Project No.  
**9769.000.000**

April 4, 2019  
Revised April 23, 2019

Subject: Encinal Terminals  
Alameda, California

## RESPONSE TO BCDC ECRB COMMENTS – FIRST APPROVED MOTION

**EXHIBIT 1: Excerpt of Figure 1 from Rogers/Pacific Inc. (1991)  
Contours of the depth to bedrock in feet below Sea Level**

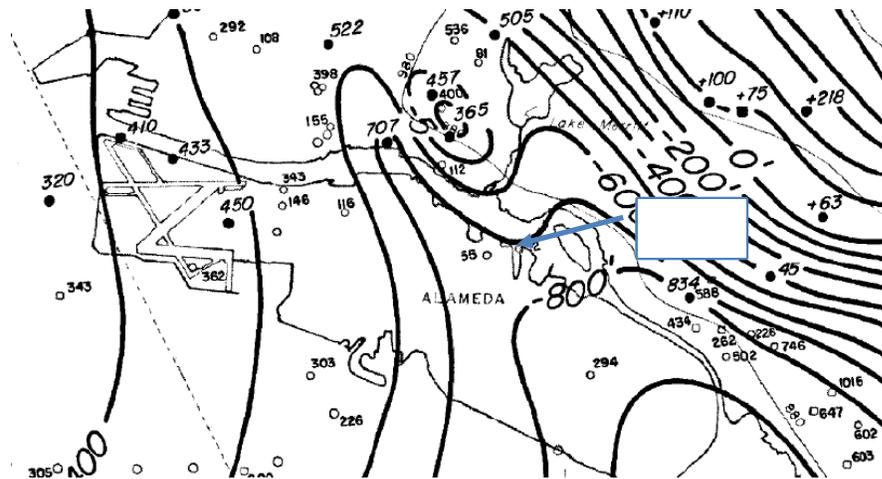
1. There was discussion by Board Chair Borchardt and Board Member French regarding the approach taken to perform the site response analysis and concern that the analysis was not performed by inputting the ground motions at bedrock in the seismic response models.

*Committee Member French noted that there will be a contribution in the soil response if you look at it from the point of view of input motions at the base of the rock, and Committee Member French asked if there had been a lot of response coming up through fairly thick Old Bay Clay. And Chair Borchardt stated that the thicker sections will contribute to the longer periods, and that is of interest with respect to this project: because of the extent of the wharf, some of these longer periods are going to come into play. And the Board's approved motion requires the designers to ensure that site responses down to 500 feet are taken into account.*

**We performed our site-specific ground motion response analyses in accordance with the American Society of Civil Engineers Standard ASCE 7-10, "Minimum Design Loads and Associated Criteria for Buildings and Other Structures." In particular, we point out Section 21.1.2 which states, "Where very deep soil profiles make the development of a soil model to bedrock impractical, the model is permitted to be terminated where the soil stiffness is at least as great as the values used to define Site Class D in Chapter 20." According to "Engineering Geologic Site Characterization of the Greater Oakland-Alameda Area, Alameda and San Francisco Counties, California," by Rogers/Pacific Inc. (1991), the depth of bedrock at the site is approximately 700 feet or more (Figure 1 of 7). Therefore, in accordance with ASCE 7-10, we created a site-specific target spectrum for a Site Class D, including basin effects due to 600 feet of soil above the bedrock and matched our selected earthquake time histories to this target before inputting them at the base of our ground response and Plaxis models.**

**EXHIBIT 2: Map of 1956 Historic Shoreline with Site Boundary Overlay**

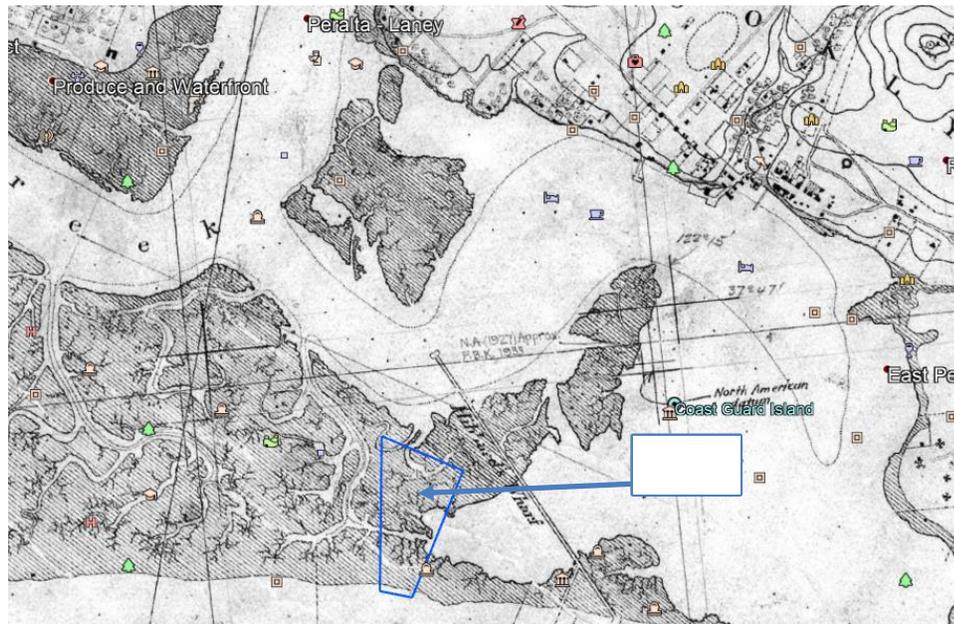
3. There was concern by Board Member Gilpin regarding the site characterization and the geomorphology of the site matching the analysis cross sections. In particular, there was question regarding the accuracy of the Cone Penetration Tests and Young Bay Mud in relation to the historic mapped shoreline.

*Committee Member Gilpin requested to see a contour map. Committee Member French agreed that it would be good to make sure that the stratigraphy makes sense geomorphologically. And the Board's approved motion requires the designers to provide a geotechnical contour map with thicknesses and elevations.*

**For the purposes of clarity, the majority of the site was mapped as a marsh prior to development. The following image shows an overlay of the site boundaries (in blue) over the 1856 US Coast Survey of the San Francisco Bay. Exhibit 2 shows an excerpt of the shoreline map with the Encinal Terminals site added.**

The shoreline shown in our report is the intertidal shoreline with the marsh terminating near the southern end of the site. The majority of the existing site boundaries were created by dredging into the marsh. As can be seen in the “Contours of the Bottom of the Younger Bay Mud,” Plate 3 in Special Report 97 (SR97) by the California Division of Mines and Geology, there is a known “Bay Mud Trough” that runs East to West through the Northern portion of Alameda Island. The mapping in SR97 indicates the trough terminates to the West of The Encinal Terminals site. Exhibit 3 shows an excerpt of the map in SR97. This same Bay Mud Trough is shown in less detail in Figure 7 of 7 from Rogers/Pacific Inc. (1991) as shown in Exhibit 4.

**EXHIBIT 5: Conceptual Seismic Instrumentation Plan**

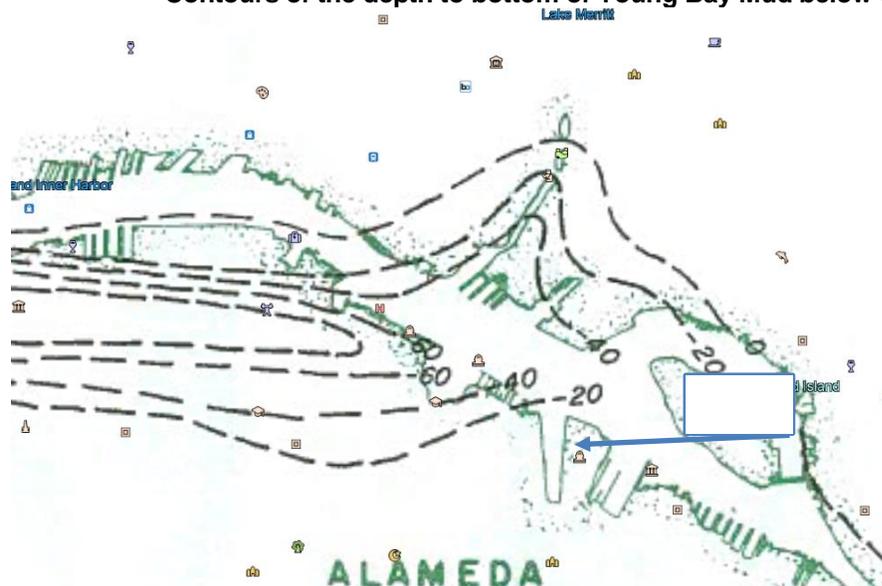
5. The final portion of the approved Motion says:

*and to clarify for staff the public access criteria for the wharf.*

Based on discussions with BCDC staff, we understand that this comment should be interpreted to apply to the retrofit portion of the wharf, as the first approved motion related to the retrofit portion of the wharf. Exhibit 5 shows the approximate boundary of the retrofit portion of the wharf as the location of the red line; beyond that point, the wharf will be terminated. Within the retrofit portion of the project, the engineering criteria for the wharf include the use of the BES-2 level earthquake (per ASCE 41) developed using site-specific site response analysis as the seismic input. We provided estimates of seismic lateral deformation of the soil below the wharf based on numerical modeling with recorded time histories scaled to the site. The wharf performance under inertial and kinematic loading at the BSE-2 level earthquake was evaluated using the structural performance guidelines in ASCE 61. We are in communications with BCDC staff regarding response to the second approved motion.
